13 March 2023

**SUBMISSION TO DA 2022/0469
NO. 1102 BARRENJOEY ROAD, PALM BEACH
CONSTRUCTION OF SHOP TOP HOUSING**

Proposed Section 1 Drawing

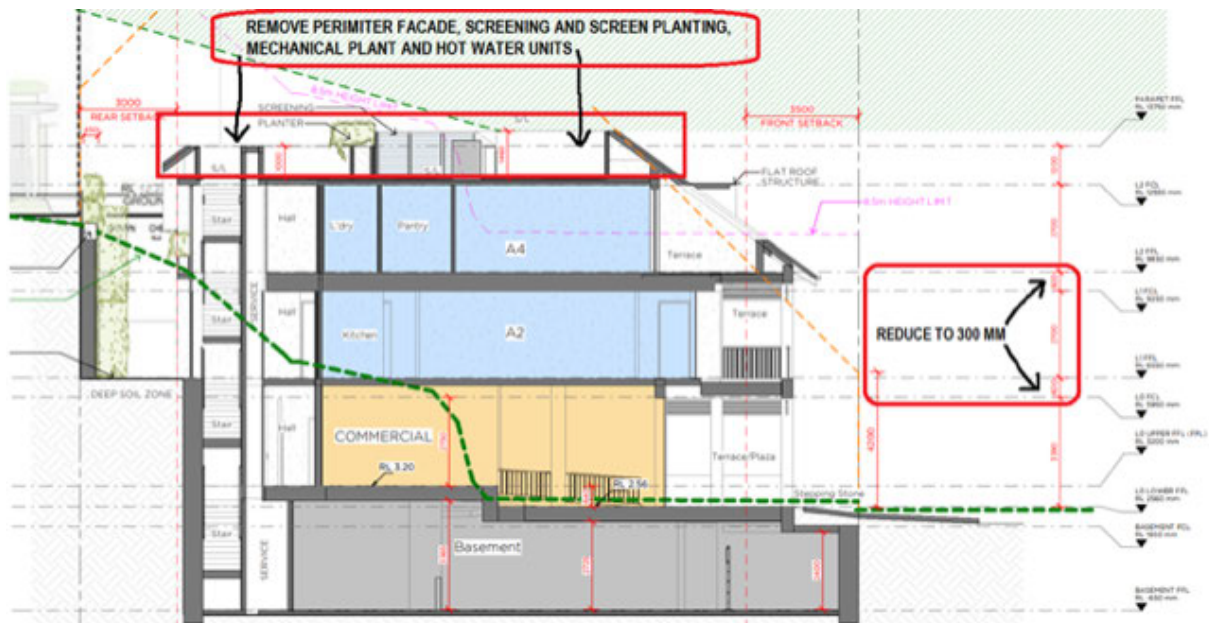
- b. In addition, further height reduction could be achieved by reducing the distance between the ceiling height of the ground floor level and the floor height of level 1. And similar between the ceiling height of level 1 and the floor height of level 2, reducing both from 600mm to 300mm (see section drawing below). This would reduce the height of the building by a further 600mm to RL 12.15m without materially effecting the currently proposed ceiling levels.
